Report to Sydney Central City Planning Panel

| Panel reference | 2017SWC032 |
| DA number | SPP-17-00002 |
| Proposed development | Warehouse or distribution centre |

Figure 2. Marked up extract of the Building 1 Site Plan (Plan reference AA04) identifying the location of the encroachments into the 10 m street setback

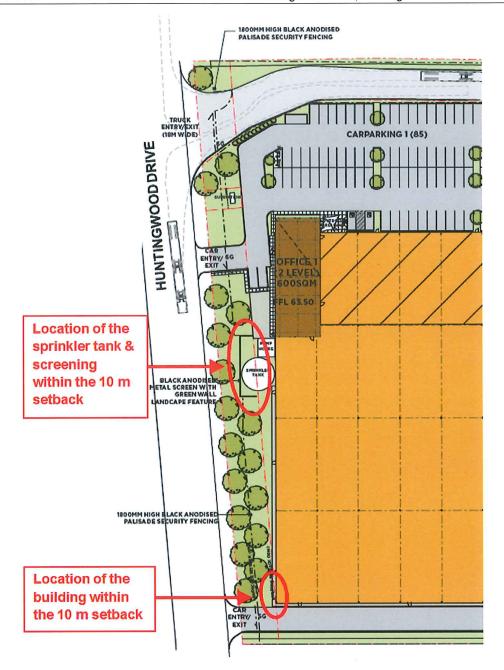
a. A minor portion of the building encroaches into the 10 m setback to Huntingwood Drive by up to 882 mm. A sprinkler tank and associated screening also encroach into the 10 m street setback by up to 5 m. The location of these variations to the building setback control are shown in Figure 2 below.

c. As shown in Figure 2, the alignment of the proposed building is offset with the property boundary. Although a minor portion of the building, the sprinkler tank and its associated screening structures encroach into the setback area, this is offset by the western portion of the setback area which has an increased building setback of up to 19 m, and a large open area which accommodates 2 driveways and a car parking area. Overall this approach provides a high quality and interesting design as viewed from the public domain. So the encroachments into the 10 m setback are considered to be acceptable in this instance, in view of the 9 m offsets provided.

b. This approach is considered acceptable given these structures are incorporated into the design of the building façade and will be screened by landscaping. In particular, the sprinkler tank will be screened by a black anodised metal screen to the full height of the tank, with climbing plants attached which will create a green wall effect on the metal screen and general landscaping. The 'green wall' is to consist of suitable climbing plants and all landscaping will be irrigated and managed as part of a monthly maintenance program to ensure its viability. Refer to Figure 3 below.
